**STAFF REPORT**  
**(One-Step Final Plat)**

**CASE NUMBER:** S/D 99-85 -- DONALDSON-TALBERT ADDITION

**LOCATION:** North side of MacArthur Road, East of West Street

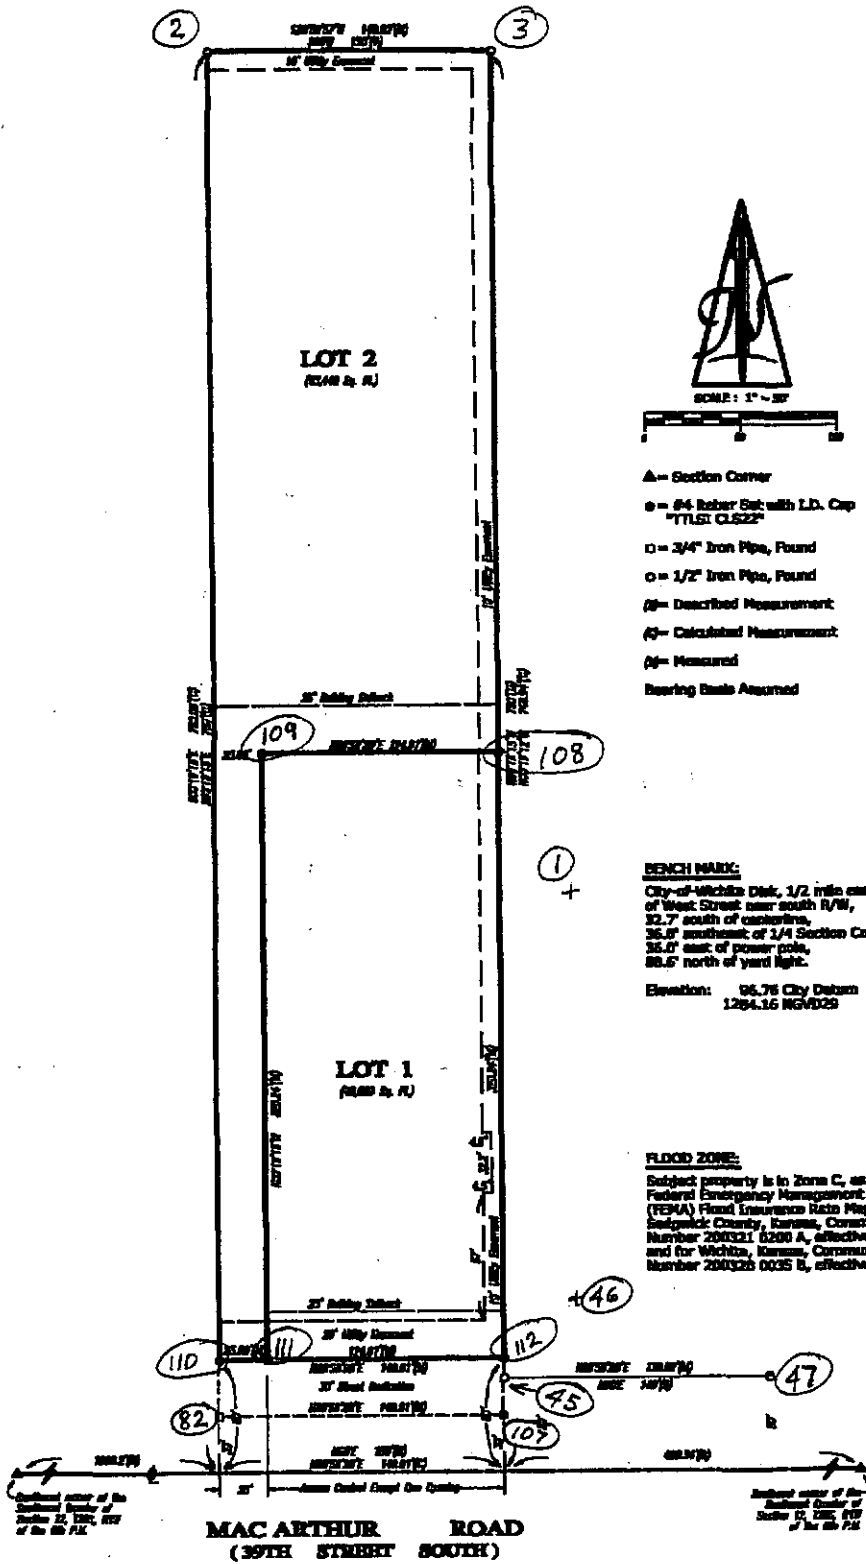
- F. Complete access control should be dedicated along the frontage to Lot 1. The width of the "flagpole" should be increased to 40 feet. An access easement should be platted within the flagpole for the benefit of Lot 1.
